Rezoning Transportation Analysis

Petition Number: #2022-161

Revision Log:

Date	Description
02-23-23	First Review (PDM)
04-20-23	Second Review (PDM)
05-24-23	Third Review (DR)

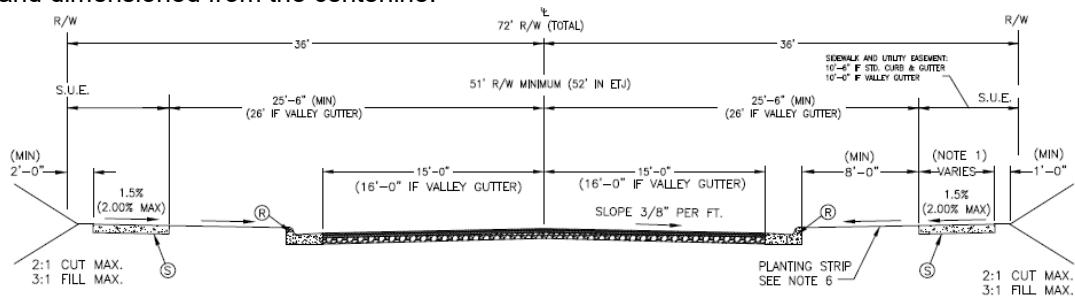
- a. ~~**Steele Creek Road:** Location of the future curb and gutter to be installed at 33 feet from roadway centerline to accommodate the Charlotte Streets Map roadway typical section of four plus lane avenue with shared use path. The future curb and gutter should be shown on the plan and dimensioned from the centerline.~~

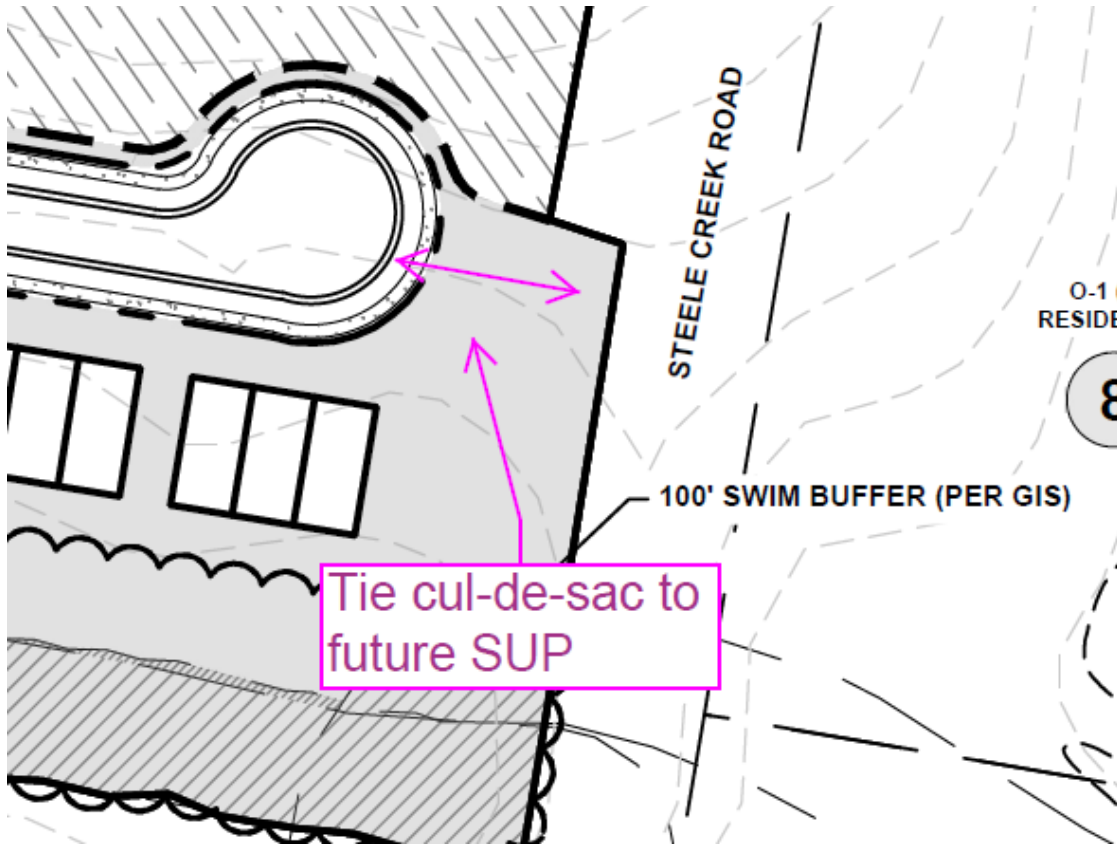
~~4. Revise site plan and conditional note(s) to show the previously approved sidewalk and the curb and gutter along Parkside Crossing.~~

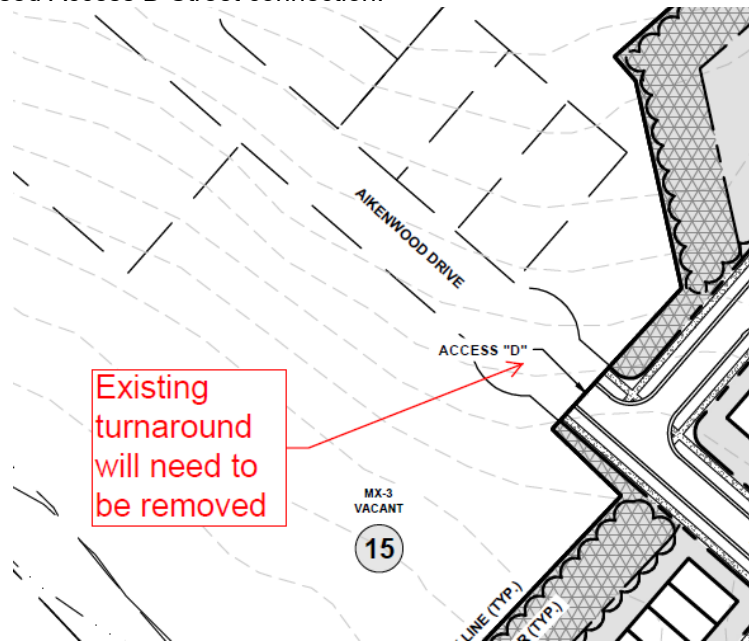
~~6. CDOT REQUEST: Revise site plan and conditional notes to commit to providing a 12-ft multi-use path connection from the proposed cul-de-sac to the proposed MUP along Steele Creek~~
